Re: FPL Lauderdale Plant
Operation below Steam Injection Curve

Re: FPL Lauderdale Plant - PSD Permit Amendment
Rate of Operation During Compliance Testing
0110037-001-AC, PSD-FL-145

RE: FPL Lauderdale Repowering Project
Request for Modification of Certification
Final Order

Figure SFWMD6-1 LAUDERDALE PLANT WASTE SYSTEM FLOW DIAGRAM

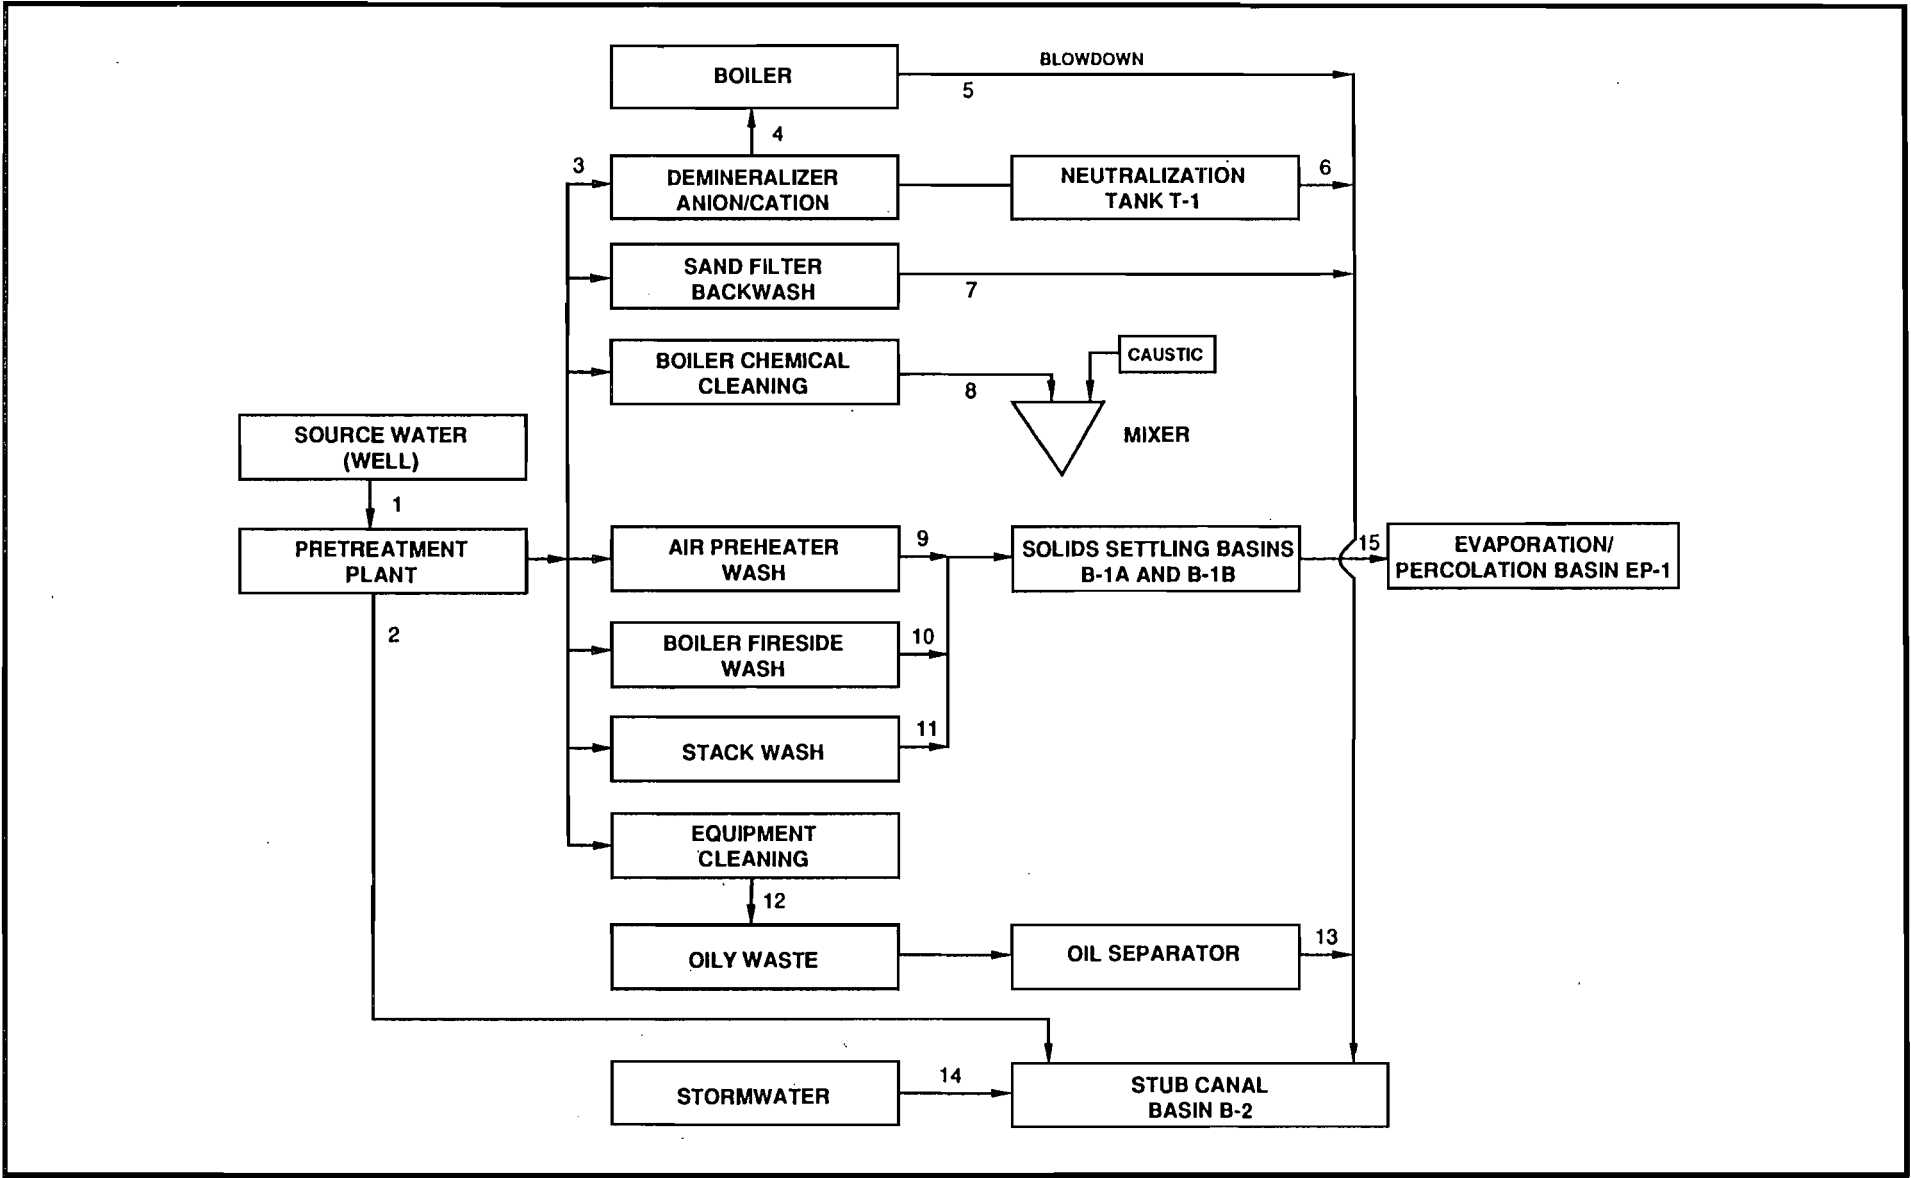
2.3.3 Site Water Budget and Area Users--Please provide a figure equivalent to Figure 3.5-1 (Proposed Water Uses Simplified Flow Diagram) for all existing plant water uses.

Response: The most recent figure of this type was included in the NPDES renewal application submitted in May 1986. A copy of that figure and the table explaining it are provided as Figure SFWM6-1 and Table SFWM6-1, respectively. Although this figure depicts wastestreams rather than water uses, it does show all the uses. The source water is off-site wells.

SITE DRAINAGE

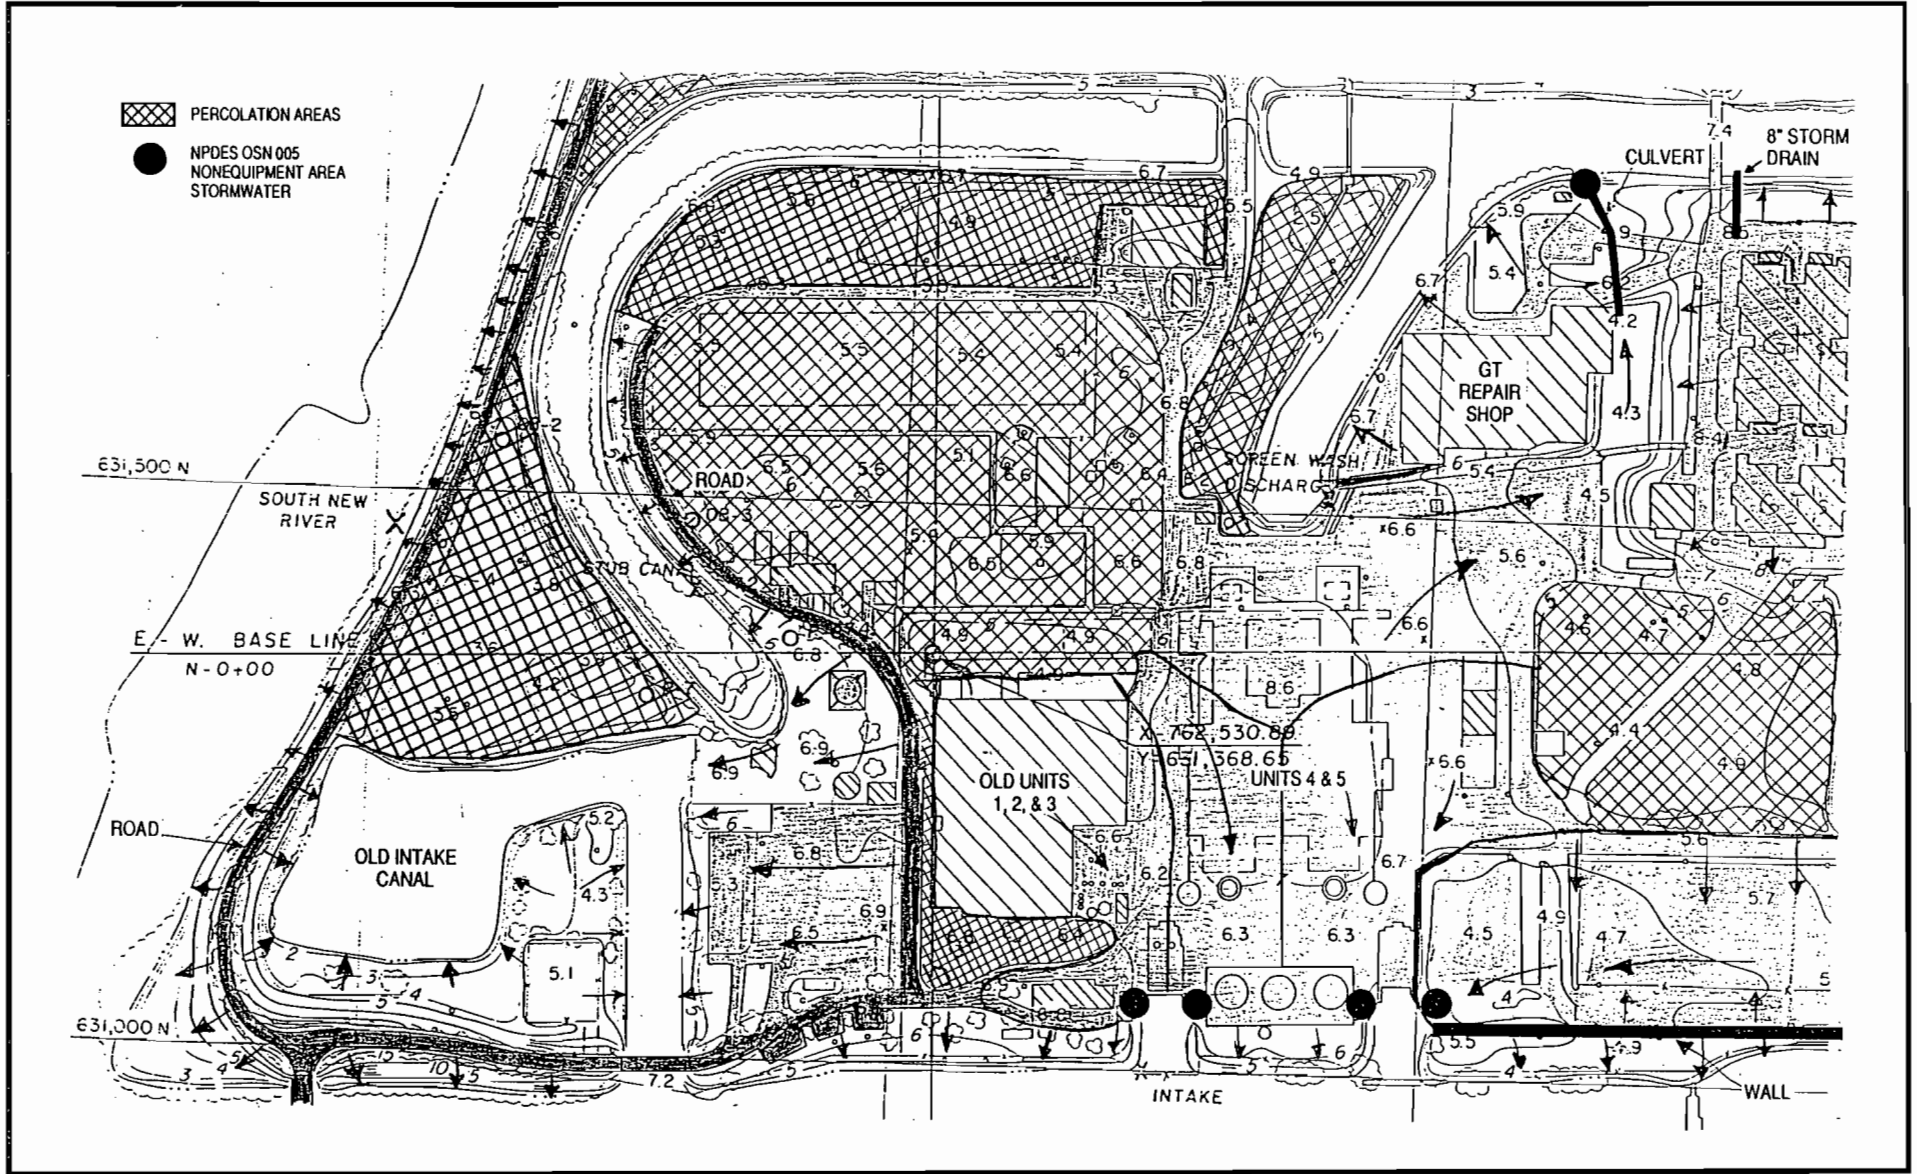
Comment: 3.8 On-Site Drainage--Please revise Figures 3.8-1, 3.8-2 and 3.8-3 (Site Drainage - Western, Eastern, Northern Portions of Site) to reflect existing and proposed on-site flows of runoff. How will runoff from impervious surfaces be conveyed (i.e., culverts, swales, etc.) to the proposed water management area(s)/runoff pond? Please clarify how the "restored" areas (after construction of the repowering project is completed) will be incorporated into the proposed surface water management system? Please provide locations, design details, and dimensions for all existing and proposed drainage structures on the plans and/or in text form.

Response: Figures 3.8-1, 3.8-2, and 3.8-3 reflect proposed on-site flows of runoff. Sections 3.8.3 and 3.8.4 have been revised (see following pages) to clarify the description of proposed on-site flows of runoff. Conveyance of runoff from impervious surfaces is described in Section 3.8.4 as overland flow, and incorporation of restored areas is discussed in the same section. Locations, design details, and dimensions for all existing drainage structures are included in the site drainage section added to Section 2.3.4.1, Page 2.3-64, of the SCA and in text form for proposed structures in the response to SFWMD-25.

Figure SFWMD25-1 CROSS SECTIONS OF THE STUB CANAL PERCOLATION POND

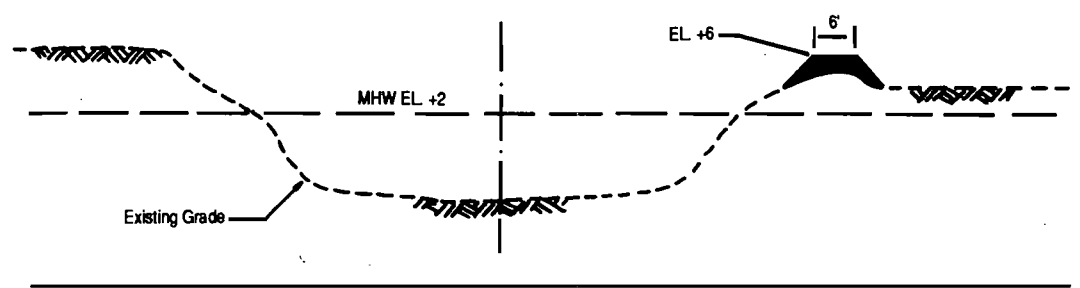
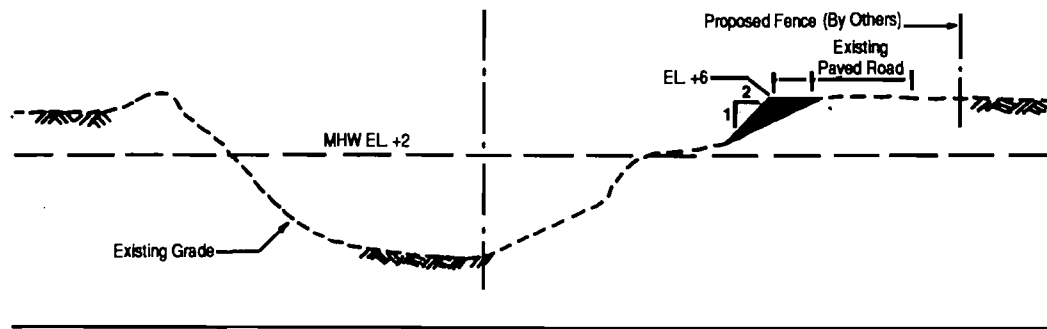
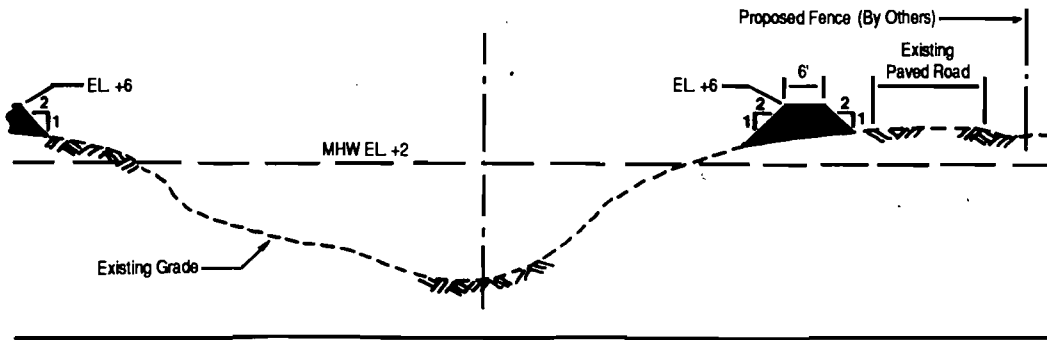
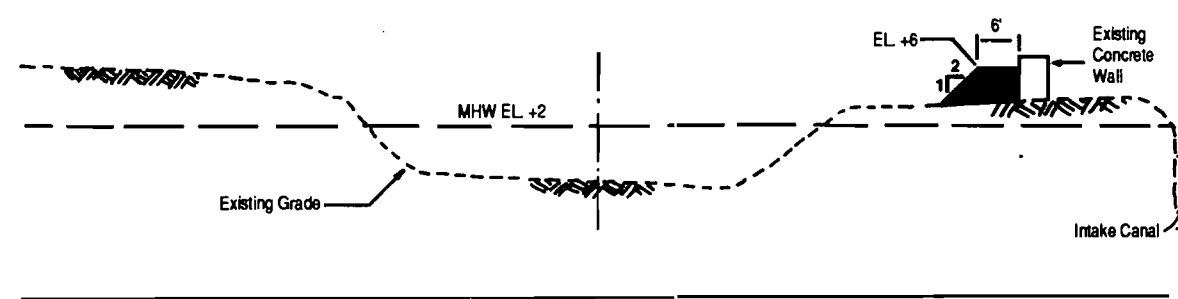
Comment: 3.8 On-Site Drainage--Please provide cross sections of the proposed detention/retention area(s) including bottom and inlet grate elevations. In order for a retention/detention area to be considered dry, the bottom elevation must be at least 1 inch above the control elevation.

Response: There are six such areas proposed, as follows:
